City of El Paso – City Plan Commission Staff Report

Case No: SUSU12-00099 Tierra Del Este Unit 71
Application Type: Major Combination
CPC Hearing Date: January 24, 2013
Staff Planner: Raul Garcia, (915) 541-493, garciar1@elpasotexas.gov
Location: South of Edgemere Boulevard and East of John Hayes Street
Acreage: 57.56 acres
Rep District: 5
Existing Use: Vacant
Existing Zoning: R-5 (Residential)
Proposed Zoning: R-5 (Residential)
Nearest Park: Tim Foster Park (1.09 miles)
Nearest School: El Dorado 9th Grade School (1.34 miles)
Park Fees Required: N/A
Impact Fee Area: This property is not located in an Impact Fee Service Area and is not subject to impact fees.
Property Owner: Ranchos Real XII, LLC
Applicant: Conde, Inc.
Representative: Conde, Inc.

ATTACHMENT 3

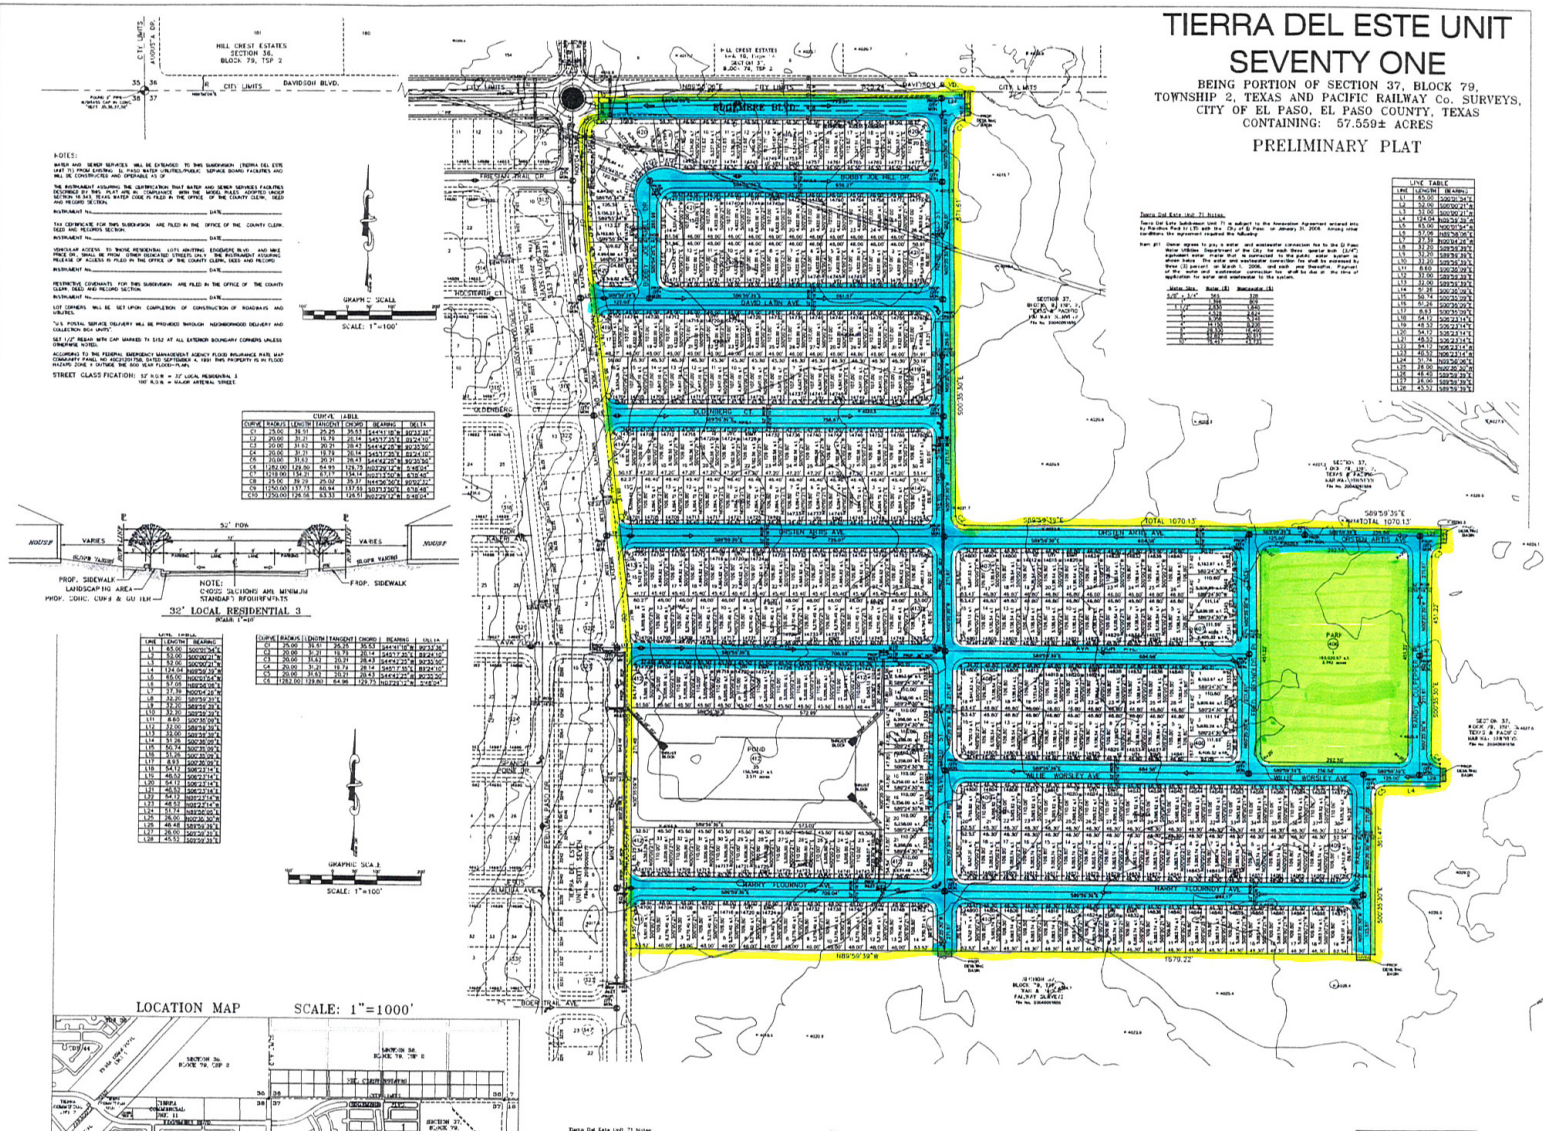
- The entire 100' ROW width of Edgemere Boulevard shall be constructed as part of this subdivision. The improvements to the portion of Edgemere Boulevard located outside of the city limits shall be included in the approved subdivision improvement plans for Tierra Del Este Unit Seventy One and those improvements are to be constructed concurrently with the improvements to the entire 100' ROW width for Edgemere Boulevard.

- Staff is recommending that the City Plan Commission require the applicant to landscape the parkway area on Edgemere and Mike Price, as stipulated under Section 19.23.040(H) *The city plan commission may require that a parkway at the rear of a double frontage lot be landscaped or other aesthetic treatment be provided by the subdivider, subject to the approval of the city plan commission to provide a visual and physical separation between the development and the street.* Staff also recommends that if the City Plan Commission requires landscaping, that the condition be coordinated with the El Paso Department of Transportation where it conflicts with site visibility standards, utilities, and parkway illumination. For the type of landscaping, staff recommends the developer select trees designated as median/street/right of way appropriate from the City's Plant and Tree List, to be placed 30-feet on centers.

1. Tierra Del Este Unit 67 shall be recorded prior to Tierra Del Este Unit 71 in order to provide vehicular access from Mike Price.
2. Edgemere shall be constructed to City standards to include the full 100' width of the street at all locations abutting the development and improvements shall be included on the subdivision improvement plans. The Department of Transportation recommends against the proposed "Alternative 1" shown on the proposed cross-section for "Major Arterial Street" as the full width of the street shall be constructed to city standards.

3. Traffic calming measures such as medians, curb extensions, and/or traffic circles are required along Neil Shed, Orsten Artis, Harry Flournoy, and Willie Cager in accordance with Section 19.15.010.E. – Traffic Calming, the Neighborhood Traffic Management Program and with the Design Standards for Construction and are to be coordinated with Department of Transportation.

- a. Additionally, traffic calming measures are recommended to be installed along the other streets abutting the park (Orsten Artis between Fred Reynolds, Randy Culpepper, Willie Worsley), and along Mike Price and Ralph Seitsinger especially where they abut the proposed school site as indicated in the approved land study.

4. The proposed name for Mike Price Dr. is in conflict with Section 19.15.140 – Street Names and Addresses as Tierra Del Este Unit 67 shows the street name as John Wayne.

- e. Pebble Hills and Rich Beem (\$14, 333.29)
 - f. Pebble Hills and Tim Foster (\$21,765.36)
 - g. Pebble Hills and John Hayes (\$32,913.48)
6. Double frontage lots along Edgemere, Mike Price, Ralph Seitsinger, and Tim Floyd shall comply with Section 19.23.040 H (Double Frontage Lots) of the El Paso City Code.

7. Landscaping, vegetation including trees, and irrigation systems to be provided within the proposed medians on Edgemere and Tim Floyd and the landscaped areas along Edgemere, Mike Price, Ralph Seitsinger, and Tim Floyd.

1. In an effort to enhance the pedestrian connectivity and walkability between the neighborhood and the proposed school site, it is recommended that the developer dedicate and improve pedestrian rights-of-way within Block 392.
2. Foreseeing the future need, Transportation recommends the installation of two (2) two-inch underground conduits within the proposed medians on Edgemere and Tim Floyd as part of the median improvements for arterial lighting communication systems.

1. The median opening at the end of Edgemere shall be provide enough space to permit a turnaround of at least 45ft. to ensure an adequate turning radius for fire and sanitation trucks
2. Temporary breakaway guard posts with retro-reflective end of road markers or Type III barricades shall be placed at the end of Edgemere, Tim Floyd, Tim Hardaway, Bobby Joe Hill, and David Latin.
3. All proposed/existing paths of travel (accessible sidewalks, wheelchair access curb ramps and driveways) located within public rights-of-way shall be constructed in accordance with the current ADA/TAS regulations and City Design Standards for Construction.
